Solutia Inc.

Response to Comments on Workplan DNAPL Characterization and

Remediation Study, Sauget Area 1

Sauget, Illinois

CONCEPTUAL SITE MODEL OF DNAPL DISTRIBUTION

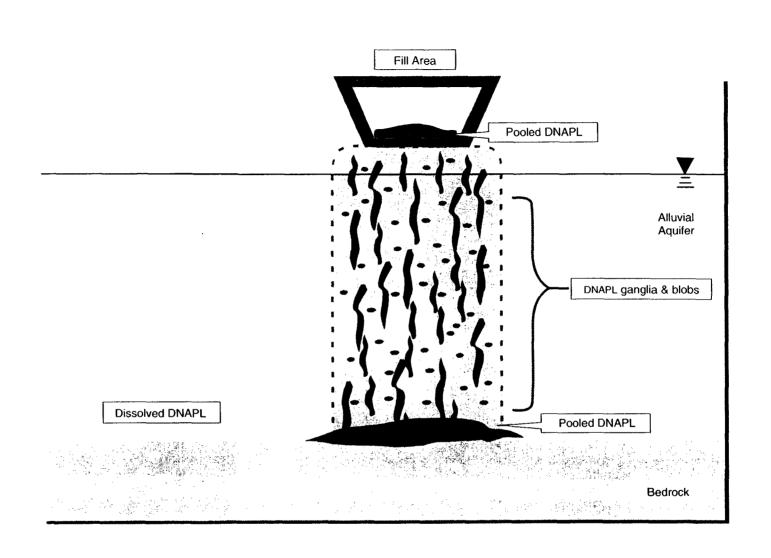
2) Section 2.0, Conceptual Site Model: The focus of this section on the high costs and possible impracticability of treating large volumes of DNAPL-contaminated fill and aquifer material is inappropriate for a work plan that is designed to address precisely these questions. This section of the work plan presents a Technical Impracticability (TI) waiver as nearly a foregone conclusion prior to any data collection or evaluation. While a TI waiver is one possible response to DNAPL contamination in Sauget Area 1, other responses are also possible and should not be dismissed so readily in the planning stages of this investigation. The DNAPL characterization study should be conducted in an unbiased, objective manner to develop the scientific and engineering data required to make a defensible evaluation of response actions. The Conceptual Site Model section of the work plan should reflect an objective evaluation of existing data without focusing on one particular response action.

RESPONSE: Section 2.0 Conceptual Site Model will be revised as shown below and incorporated verbatim into the Work Plan:

Basis for Investigation - Based on this Conceptual Site Model (Figure 4), the DNAPL Characterization and Remediation Study is focused on collecting the information needed for i) estimation of the volume of DNAPL-affected material; ii) assessment of the ability to remove DNAPL from the aquifer matrix by treatment; iii) estimation of the removal efficiencies of various treatment technologies; and iv) determination of the presence of pooled DNAPL. These data will be used to determine if aggressive source treatment will make any meaningful difference in the time required to achieve ARARs and, if so, the cost of such treatment.

Figure 1. Different Flux Reduction vs. Mass Reduction Curves. The dashed curve (Curve 3) was used for the Sauget Area 1 Source Evaluation Study.

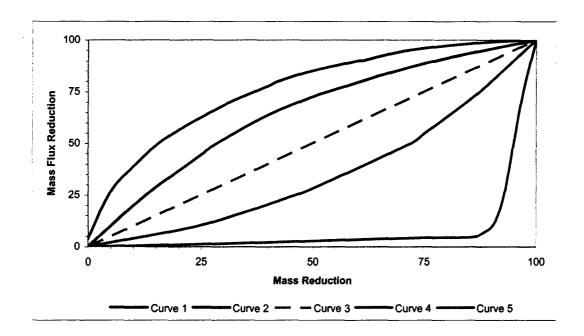
concentrations in groundwater are directly proportional to changes in DNAPLs mass in the aquifer matrix") is subject to significant possibility of error, and should be used with caution. This evaluation is limited to an assessment of the plausibility of the indicated part of the conceptual model (i.e., "changes in COC concentrations in groundwater are directly proportional to changes in DNAPL mass in the aquifer matrix."), and is not intended to review any potential effects on remedy evaluation. Because the remediation comparisons and recommendations set forth in the Workplan and Study are based on calculations of the time necessary for dissolution to remove NAPL mass, and the proportionality assumption may strongly affect the results of such calculations, it is recommended that the workplan or final report fully discuss and evaluate the reasons for using the assumption, and provide alternative approaches to estimating NAPL removal for comparison.

As can be seen in Figure 1 of the Technical Memorandum, the model assumption used in the Sauget Area 1 Source Evaluation Study will result in time to clean predictions that are roughly midway between time to clean predictions based on the low DNAPL mass removal/high flux reduction assumptions of Rao and Jawitz (2003) and Enfield et al. (2002) and the high DNAPL mass removal/low flux reduction assumptions of Rao et al. (1997) and Sale and McWhorter (2001). For this reason, it is considered appropriate to use the Sauget Area 1 DNAPL Dissolution Model (as described in the Source Evaluation Study) in Task 8 - Remedial Alternatives Evaluation of the DNAPL Characterization and Remediation Study.

As can be seen in Figure 1 of the Technical Memorandum, the model assumption used in the Sauget Area 1 Source Evaluation Study (changes in constituent concentrations in groundwater are directly proportional to changes in DNAPL mass) will result in time to clean predictions that are roughly midway between time to clean predictions based on the low DNAPL mass removal/high flux reduction assumptions of Rao and Jawitz (2003) and Enfield et al. (2002) and the high DNAPL mass removal/low flux reduction assumptions of Rao et al. (1997) and Sale and McWhorter (2001). For this reason, it is considered appropriate to use the Sauget Area 1 DNAPL Dissolution Model (as

Note that curve 3 represents the case where source mass reduction causes an equivalent reduction in mass flux. In other words, curve 3 reflects the assumption that concentrations in groundwater are directly proportional to changes in DNAPL mass (if there is no change in the groundwater flow field before and after remediation). This was the assumption that was used in the Sauget Area 1 Source Evaluation Study and was referenced in the DNAPL Workplan.
